Regulatory Submission for period 2021/22 to 2025/26

CITIPOWER - REVIEW OF ASPECTS OF PROPOSED EXPENDITURE

Report prepared for:
**AUSTRALIAN ENERGY
REGULATOR**
August 2020

Figure 4.21: Comparison of HI at 2019 and 2026 by transformer for CitiPower

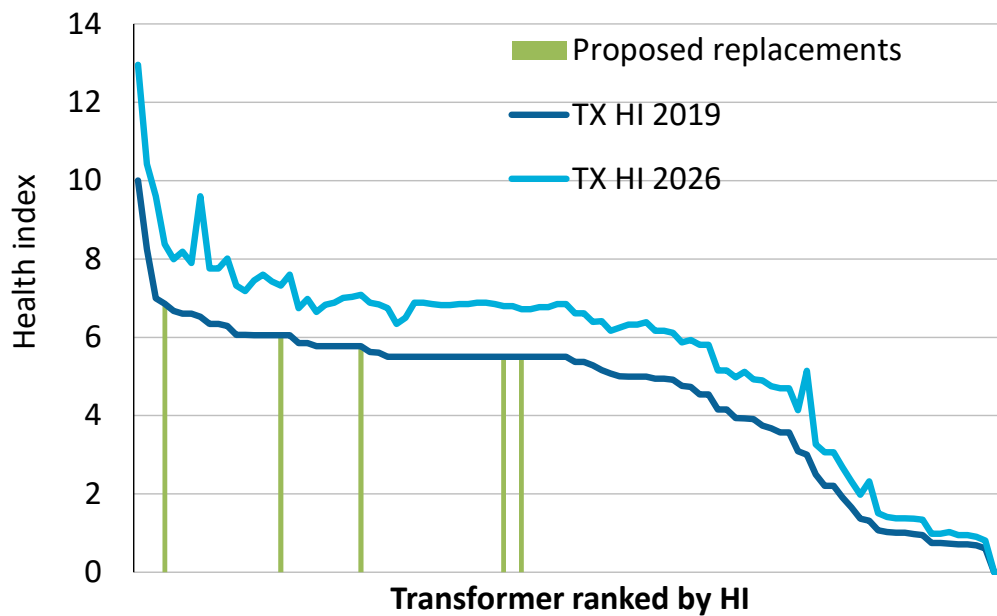
- 308. Whilst CitiPower has provided us with the volume of HI for each transformer, we have no visibility of the interventions planned for each transformer or how the options have been assessed to determine that the proposed program reflects a prudent level of expenditure.
- 309. We did gain a perspective of the effect of the selection by sorting the transformer population by HI. The results are shown below.

Figure 6.3: Cumulative NPV of the proposed 319 LV augmentations, over different analysis horizons - \$millions

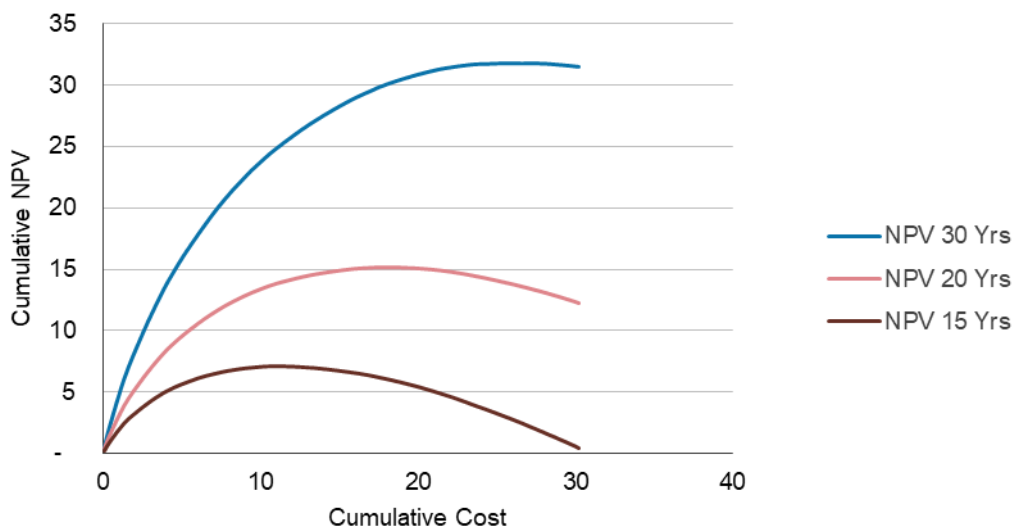
660. In Figure 6.3 below, the top line shows the cumulative NPV of each of the 319 LV augmentations that CitiPower has proposed, ordered with the highest NPV augmentations first, based on CitiPower's analysis. There is a clearly decreasing marginal benefit. Our analysis indicates that 88% of the aggregate NPV of the program would be achieved from a program of only half the size of that proposed.

661. We then tested for the sensitivity of CitiPower's result to the time period considered. The lower two lines in Figure 6.3 show the implication of adopting 20-year and 15-year horizons, respectively, for the analysis. With analysis over only 15 years, on the plausible assumption that forecasting beyond that time is too uncertain, only around one-third of the proposed augmentations would have a positive NPV. The remainder of the augmentations would have a negative NPV and in aggregate if all of the upgrades were done, the NPV of the program would be effectively zero.

682. As we have shown in Figure 6.3, when we shorten analysis periods, a large number of the proposed augmentations have a negative NPV. We also do not accept the proposition that uncertainty is accounted for by CitiPower adopting conservative assumptions. Even if conservative assumptions have been adopted, there is a range of techniques available for modelling such analysis under uncertainty, with sensitivity analysis and scenario analysis being two of the more basic techniques that can be applied.

Figure 6.4: Annuitised cost and modelled benefits for one of CitiPower's proposed transformer upgrades¹⁸¹

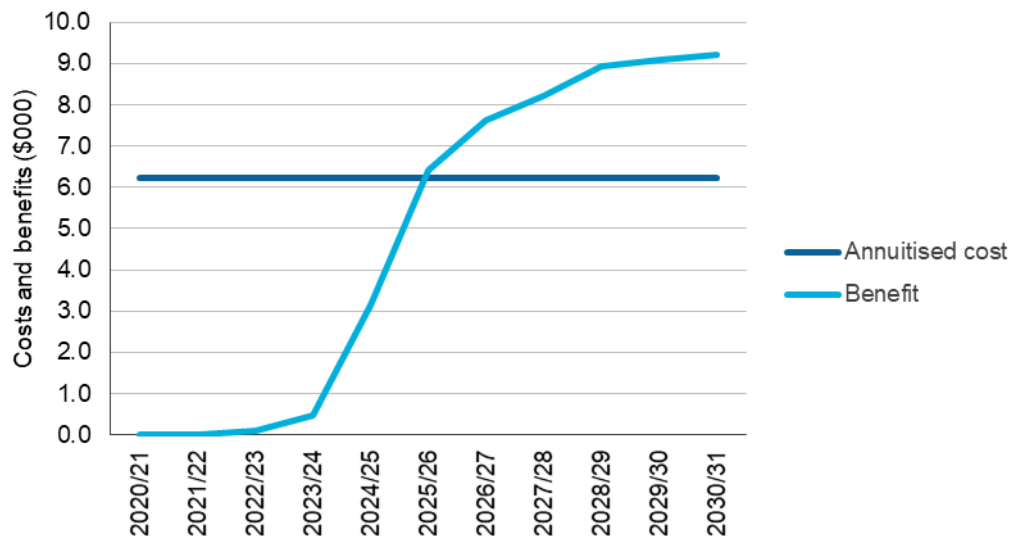
686. In Figure 6.4 we show an example of this methodology applied to a specific LV transformer from CitiPower's solar enablement analysis. In this case, it indicates that an upgrade would be warranted in 2025/26, based on CitiPower's benefit assumptions including its forecast PV uptake rate for customers connected to that transformer.

Figure 6.5: Augmentation profile indicated by identifying year when benefits exceed costs

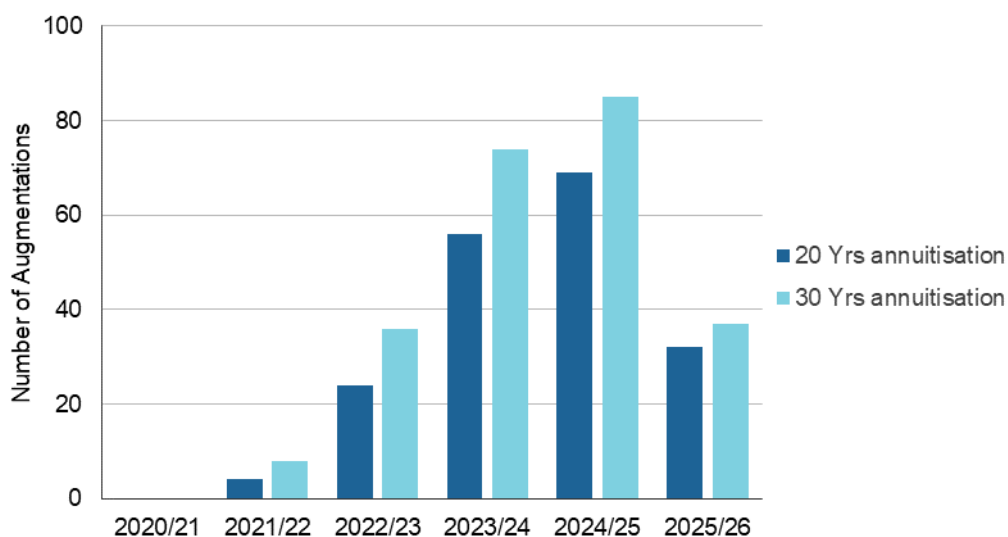
687. When we apply this method to all 319 of CitiPower's proposed augmentations, we find a profile of augmentations as shown in Figure 6.5. We have undertaken this analysis with augmentation costs annuitised over 30 years, as per CitiPower's assumptions, and an alternative forecast in which the cost is annuitised over 20 years.
688. A very small number of augmentations are indicated for the early years, which is as we would expect given CitiPower's very low current PV penetration. If the uptake rate and other benefit assumptions are as CitiPower has forecast, our analysis suggests an increasing trend of augmentations at least to 2024/25. However, our analysis also shows that under CitiPower's cost and benefit assumptions, only 240 of its proposed 319 augmentations would be viable. Further, if a 20-year annuitisation period is adopted (consistent with

Figure 6.6: Ranked Benefit/Cost ratio of 319 LV upgrades (20-year analysis)

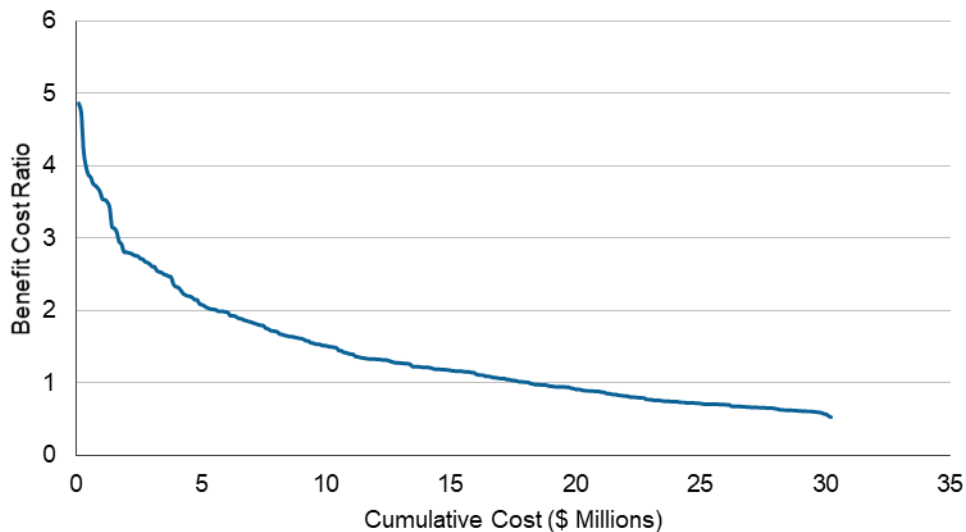
- 691. In the context of significant uncertainty, we observe that from CitiPower’s modelling, nearly 90% of the estimated benefits would be achieved from a program that involves only addressing the top 50% of LV augmentations if ranked in order of descending NPV. This rapid fall-off in incremental benefit with increasing scale of the proposed project, can be seen in Figure 6.3. It is also evident in the large number of projects with NPV close to the X axis in CitiPower’s own diagram in Figure 6.2.
- 692. We are struck by the scale of CitiPower’s proposed program, with 319 LV upgrades proposed from 2021/22 to 2025/26, relative to 48 similar upgrades that it undertook in the

Figure 8.3: Economic analysis comparison of facilities upgrade options – As proposed and with EMCa sensitivity adjustments

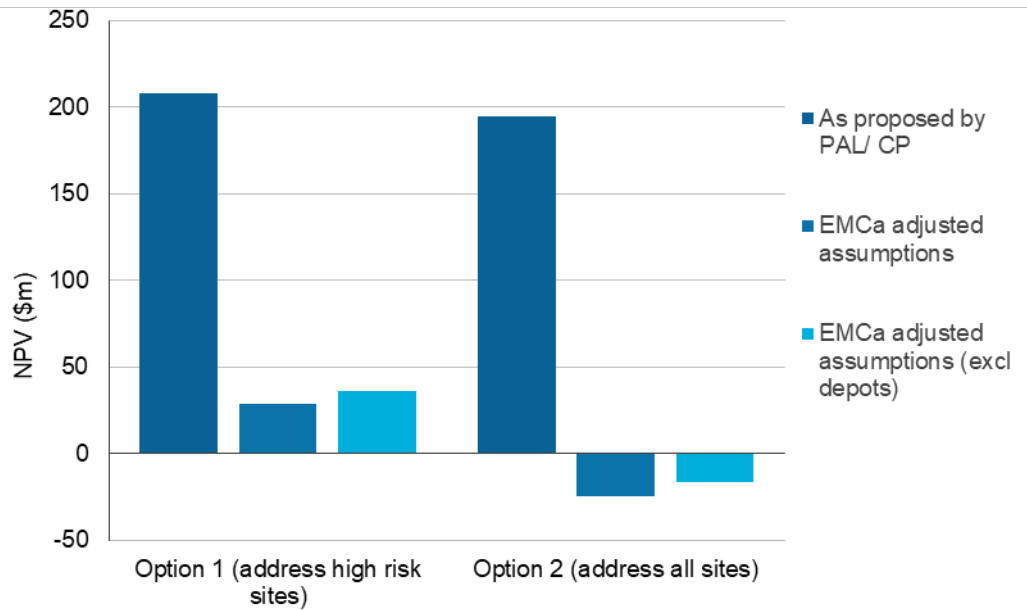
963. As presented by Powercor/CitiPower, the proposed Facilities Security upgrades have a positive NPV of over \$200m. However, our stress testing of the economic analysis suggests a much lower NPV, in the order of \$30m, though still positive as shown in Figure 8.3 below. Our testing of the CBA also supports CitiPower's proposed Option 1 as the preferred option – that is, upgrading key risk sites only.
964. Taken in conjunction with the more moderate benefit assumptions described above, we consider that Option 2 (all sites) would have a negative NPV.

968. In assessing the Powercor/CitiPower CBA model, we reviewed its sensitivity to removing all benefits attributed to depots. For consistency, we also removed all identifiable depot-related costs. As can be seen from Figure 8.3, the NPV of the program is higher when we exclude both the depot-related costs and benefits in the CBA model. This indicates to us that the depot component of the proposed facilities upgrades has a negative NPV.³¹⁷

Figure 9.3: CitiPower claimed basis for step change compared with its 2019 reported minor repairs maintenance and its reported 2019 unitised cost information - \$m, real 2021

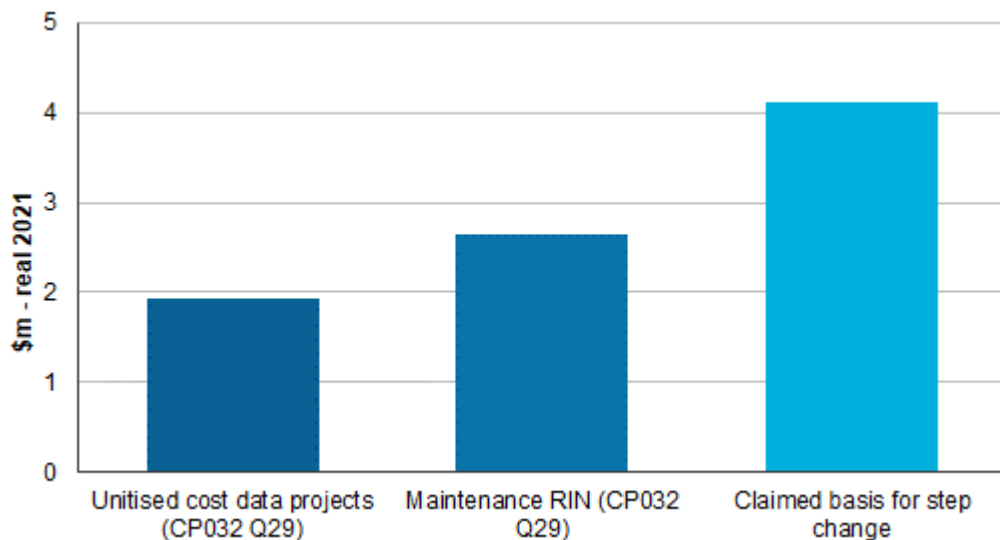
1005. We first compared the aggregate expenditure for which CitiPower provided unitised cost information. As shown in Figure 9.3, the information that CitiPower provided (which totalled \$1.9m in 2019, in \$2021 terms) did not match either its recast RIN information or the claimed 2019 expenditure basis for its proposed step change.
